ATTACHMENT 3

PROPOSED CHANGES TO TECHNICAL SPECIFICATIONS 3.1.2.1 & 3.1.2.3 AND BASES

SOUTH TEXAS - UNITS 1 & 2 3/4 1-9

CHARGING PUMPS - SHUTDOWN

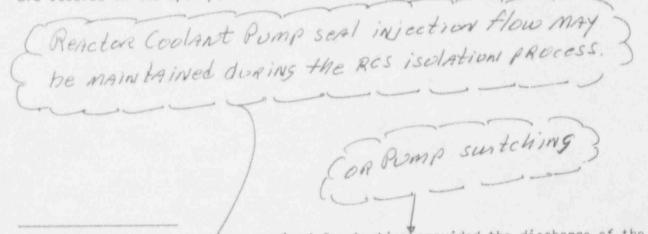
3.1.2.3 One charging pump in the boron injection flow path required by Specification 3.1.2.1 shall be OPERABLE and capable of being powered from an OPERABLE emergency power source.

APPLICABILITY: MODES 4**, 5, and 6.

**The provisions of Specification 3.0.4 and 4.0.4 are not applicable for entry into MODE 4 from MODE 3 for the charging pumps declared OPERABLE pursuant to Specification 4.1.2.4 provided chat a maximum of one charging pump is OPERABLE within 4 .ours after entry into MODE 4 from MODE 3 or prior to the temperature of one or more of the RCS cold legs decreasing below 325°F, whichever comes first.
